Car Stereo Service Bulletin

Model: CDX-71/71RF

No. 365

Subject: Controller Displays "ERROR"; Discs Load But Don't Play.

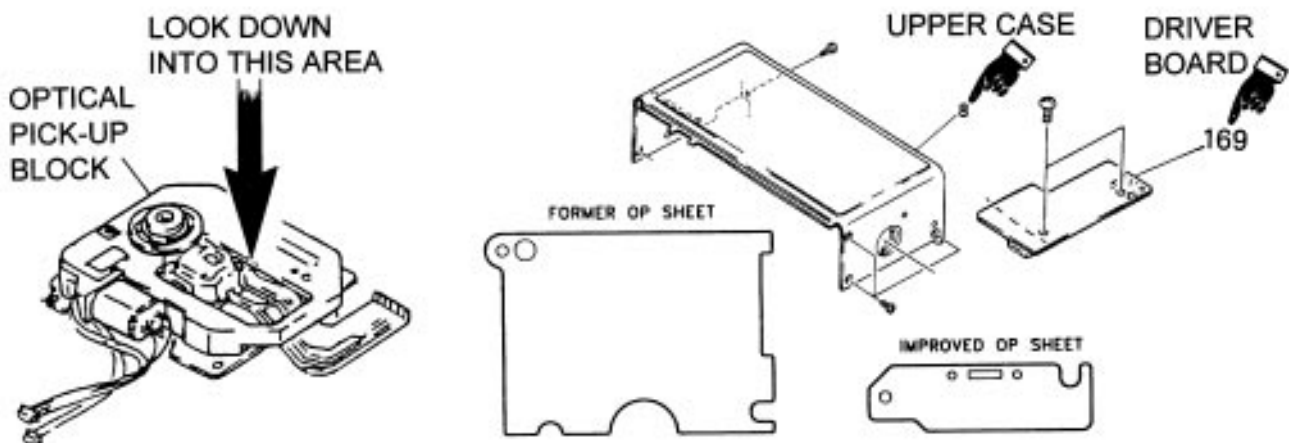
The display on the controller shows "ERROR" when the end of the current disc is reached. The mechanism loads the next disc, but will not play it. It then loads the next disc, but will not play it either. This problem may be caused by the optical pickup getting caught on the OP sheet as it tries to return to the innermost position, which prevents it from reaching the T.O.C. area of the disc.

Change the OP sheet (REF. 261) for an improved one which is smaller in size. Some units already have the improved OP sheet installed. The type of sheet in a particular unit can be identified as follows:
1- Remove the Upper Case, Ref. 8, and the Driver Board, Ref. 169.
2- Look down into the optical pickup block. If a black sheet is seen in the vicinity of the flex cable, replace the OP sheet with the improved one. If you can see the metal plate below the flex cable it is not necessary to change the OP sheet.

REF	FORMER		NEW	
	DESCRIPTION	PART NUMBER	DESCRIPTION	PART NUMBER
261	SHEET (OP)	3-919-984-03	SHEET (OP)	3-926-531-01
